LEGAL NOTICE EXETER PLANNING BOARD AGENDA

**TOWN OF EXETER
PLANNING BOARD
NOWAK ROOM
10 FRONT STREET
AUGUST 14, 2025
DRAFT MINUTES
7:00 PM**

To: Planning Board

- Site plan set entitled "Mixed Use Site Plan 97 Portsmouth Avenue" last revised 8/18/2025, prepared by Beals Associates
- "Drainage Analysis & Sediment and Erosion Control Plan" last revised 6/24/2025, prepared by Beals Associates

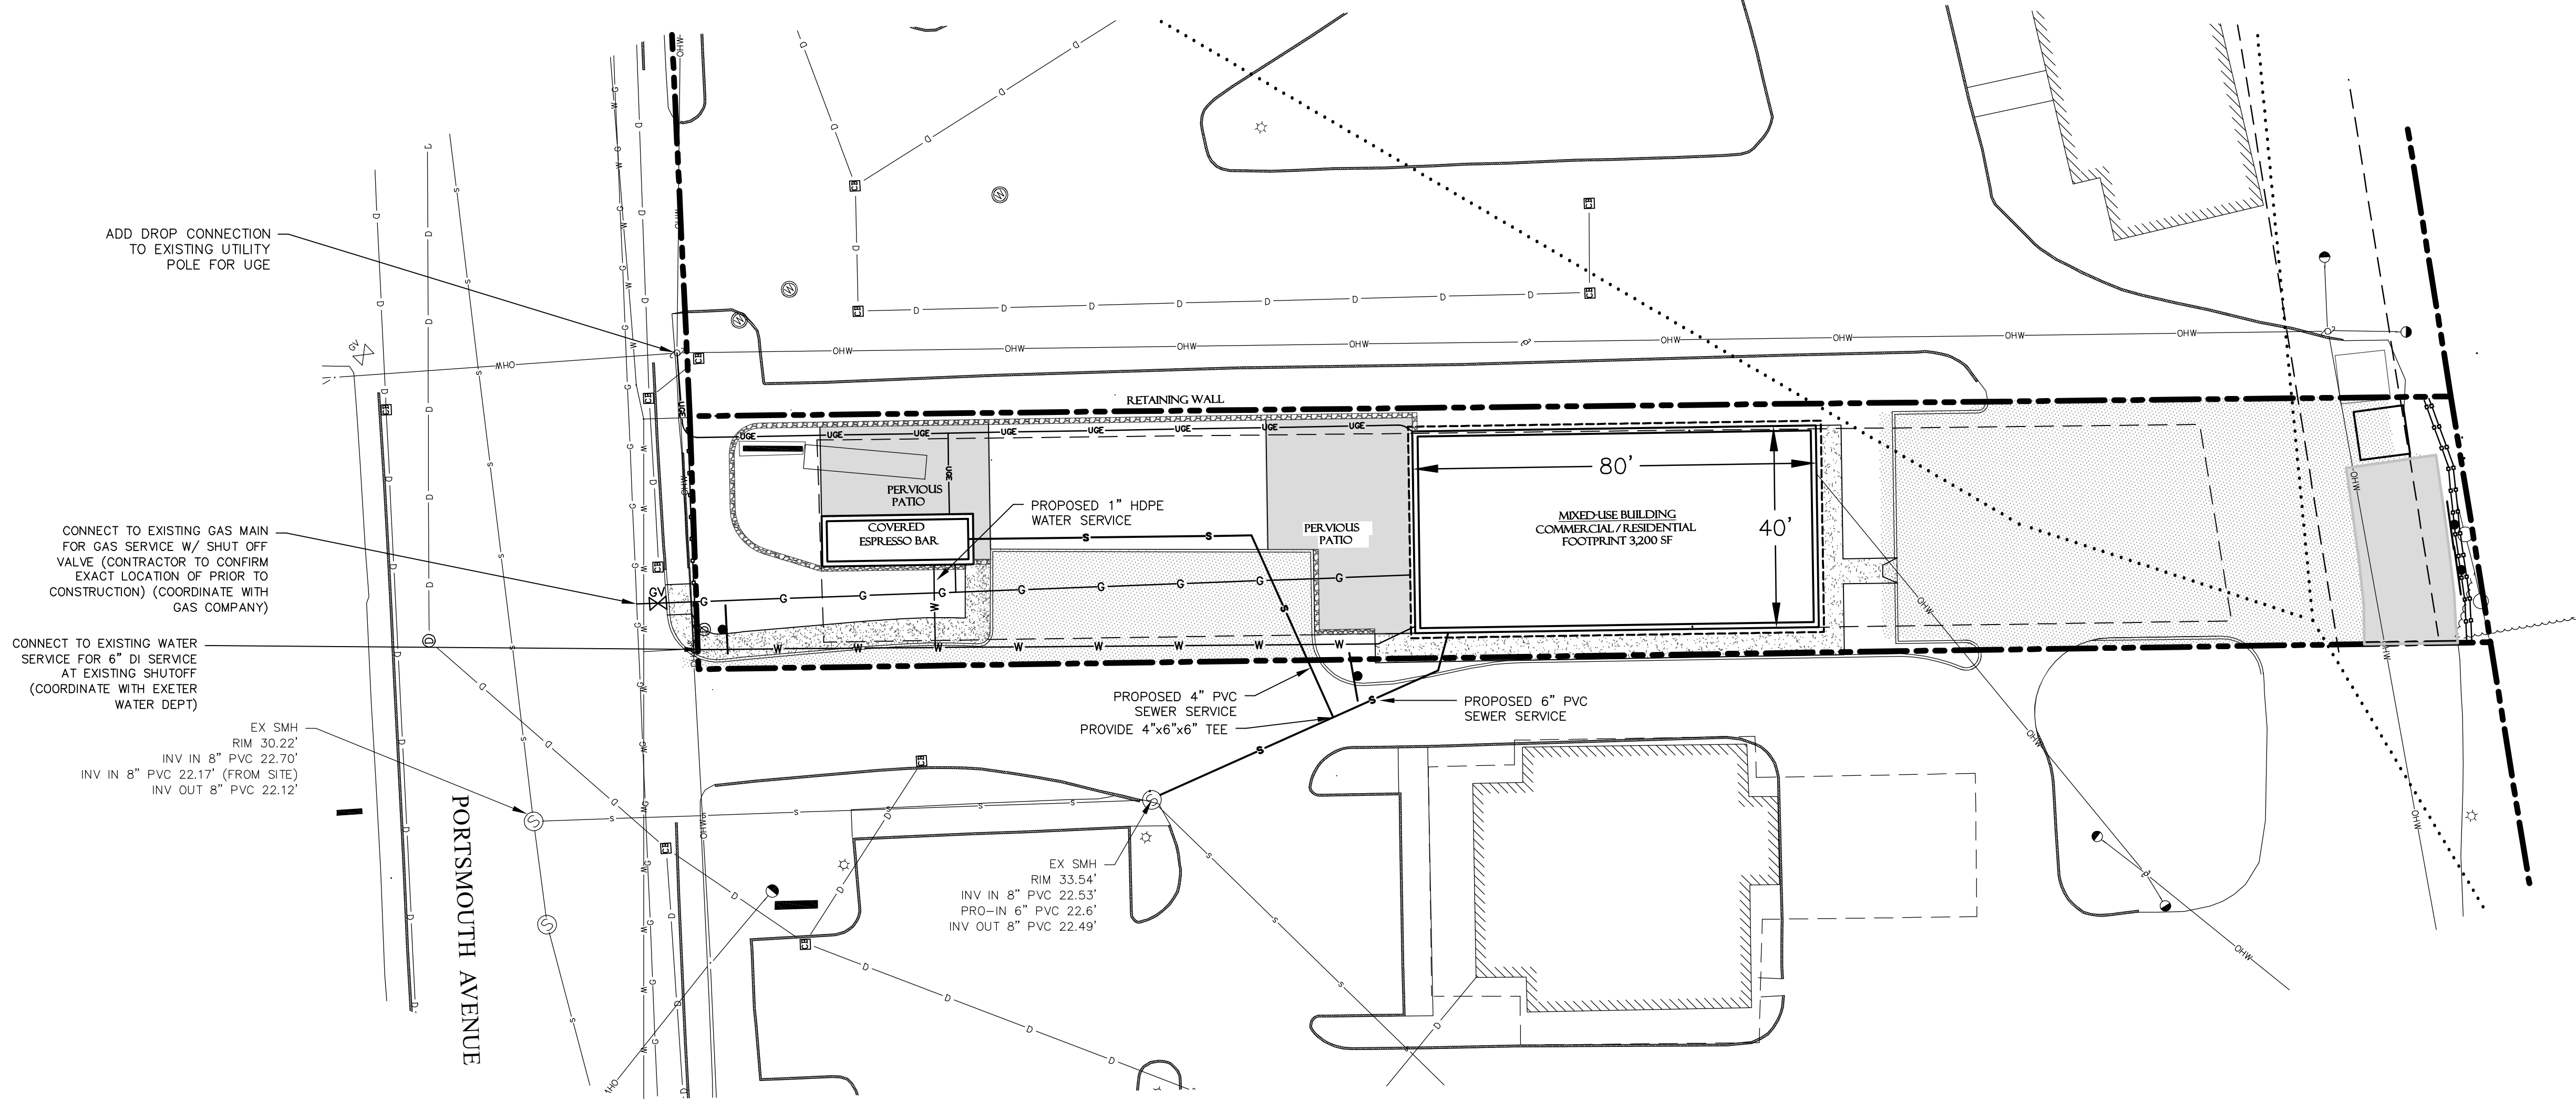
We have received existing sewer manhole data from the surveyor, and added to the plan. Sheet 6 depicts the 4" line from the espresso bar tying into the 6" line from the new building with a tee eliminating the acute angle in the former manhole connection. We have confirmed with the Exeter Sewer/Water superintendent that there are no capacity issues in the area of the proposed project in the existing mains.

Sheet 6 depicts the 4" line from the espresso bar tying into the 6" line from the new building with a tee eliminating the acute angle in the former manhole connection.

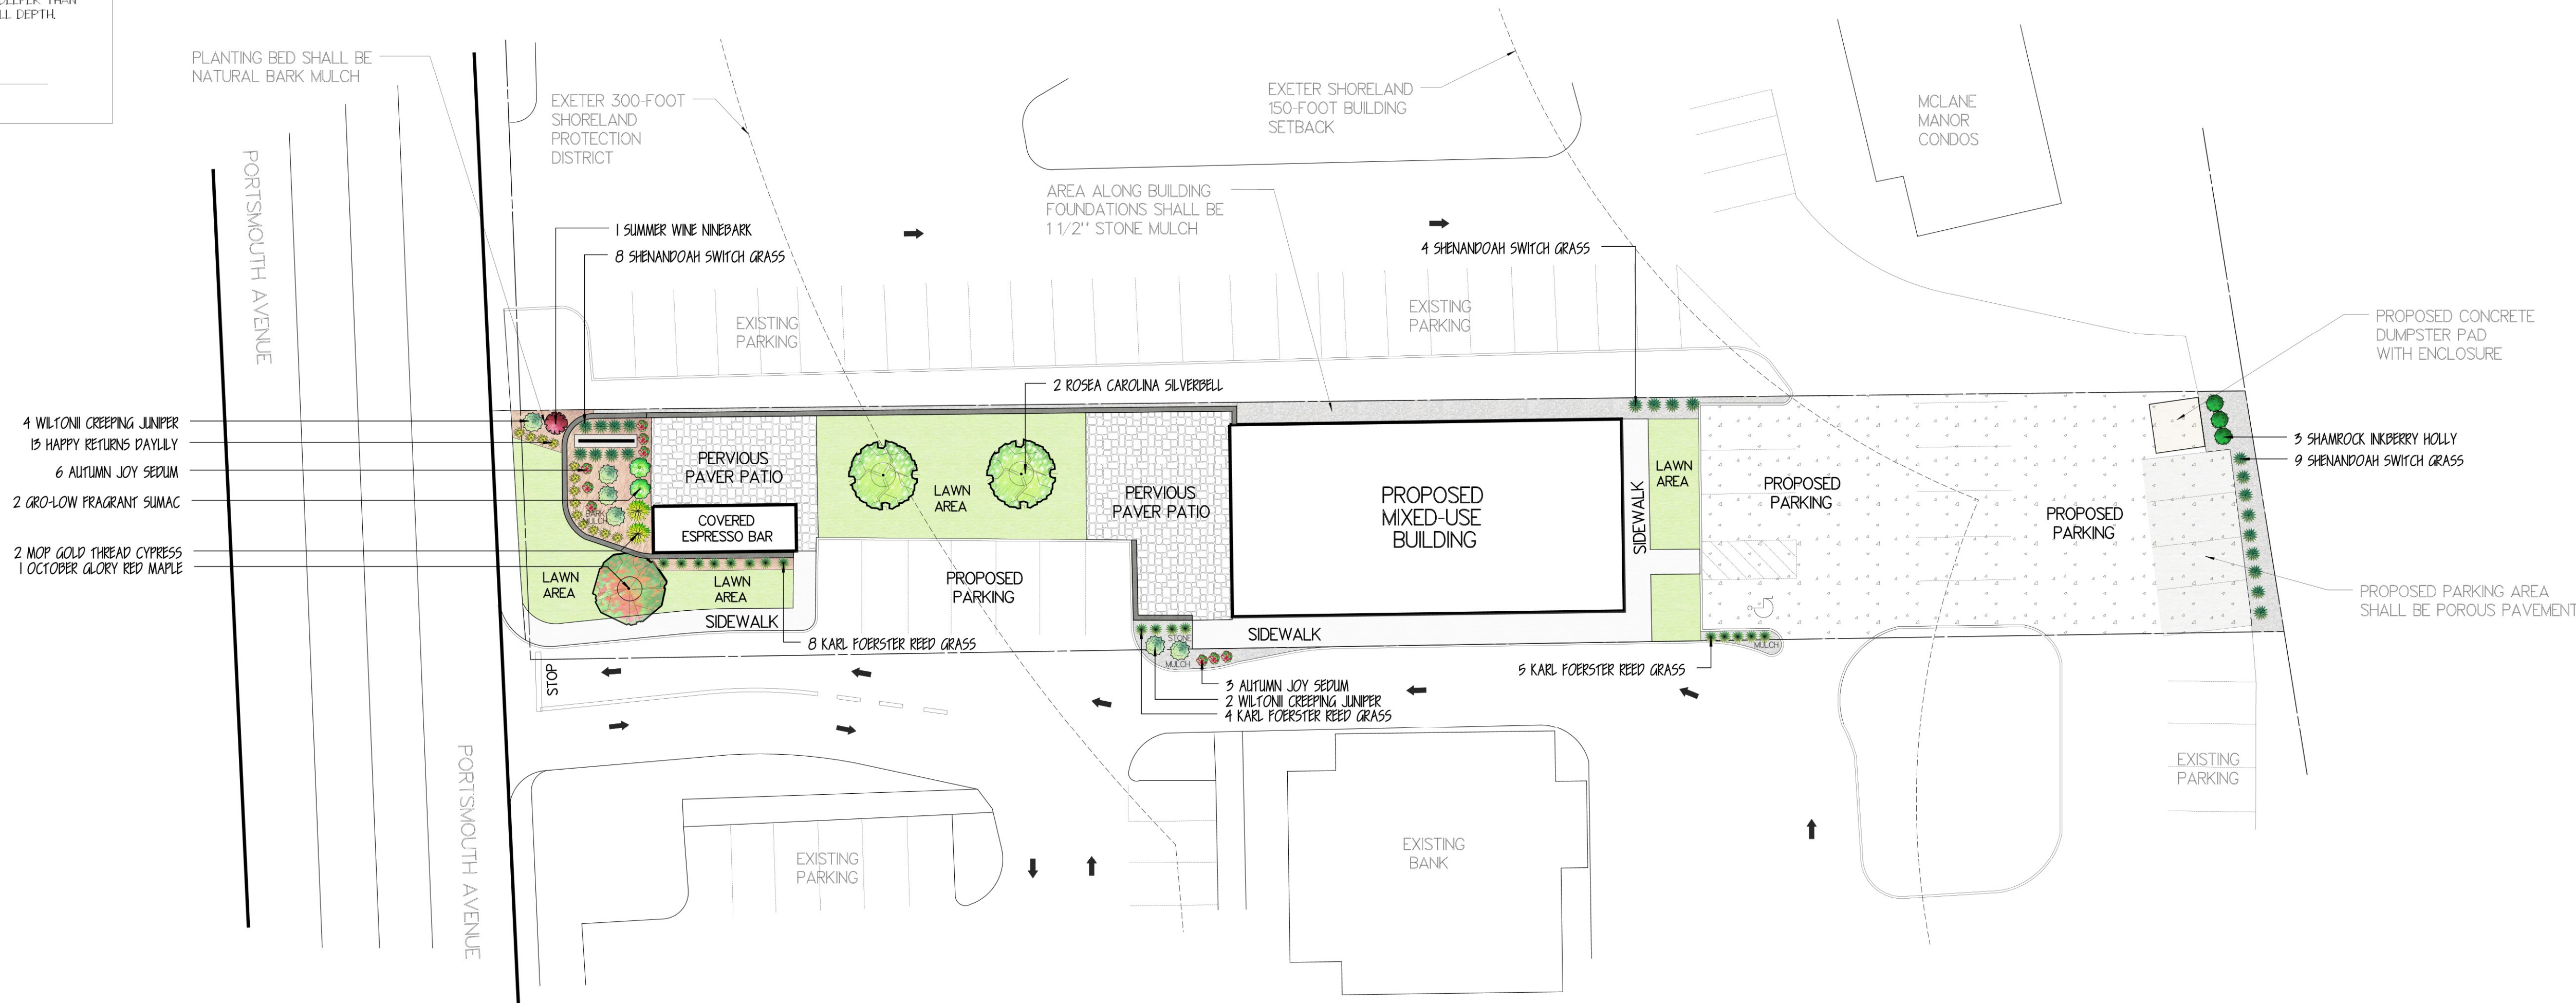
4. Planting Plan – Sheet #8 shows new plantings at the rear of the parcel, and slightly revised plantings in the two “teardrop” areas adjacent to the bank. A portion of these two areas, however, appear to extend over the property line.

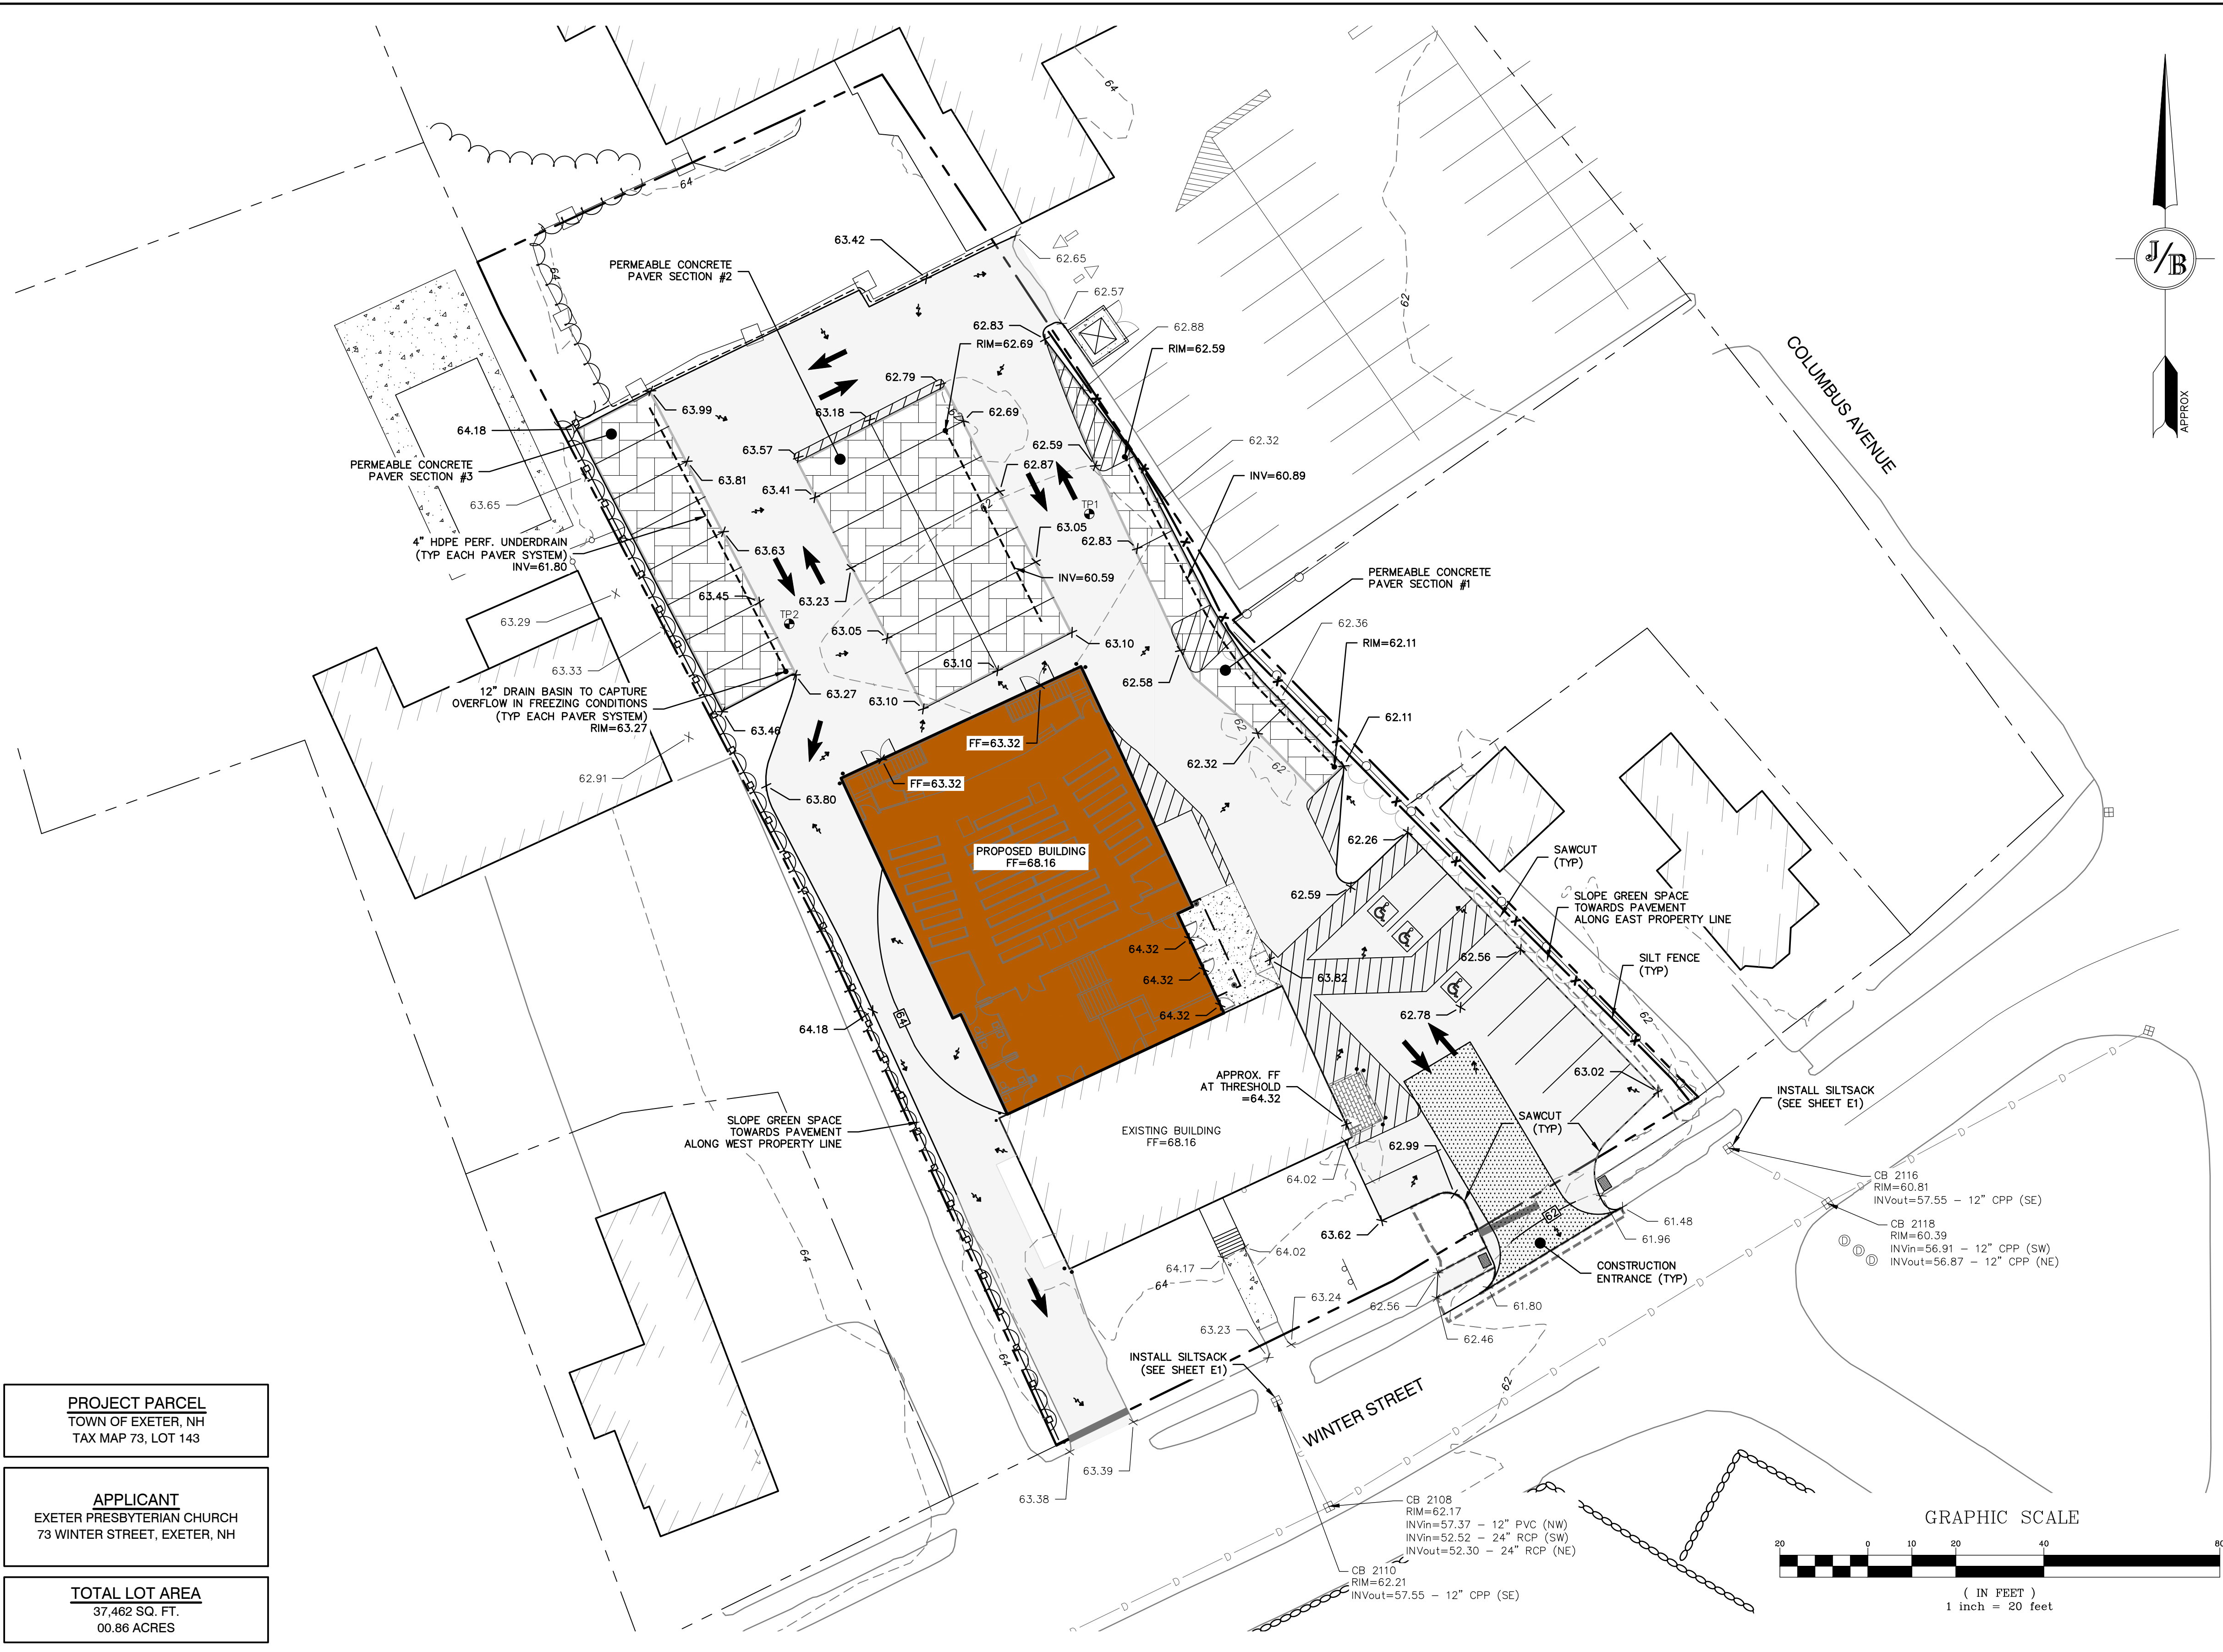
5. *Confirm the proposed location(s) for the stop sign(s). A stop sign detail is provided on Sheet D1.*

Response: The proposed locations for the stop signs has been added to Sheet C2.
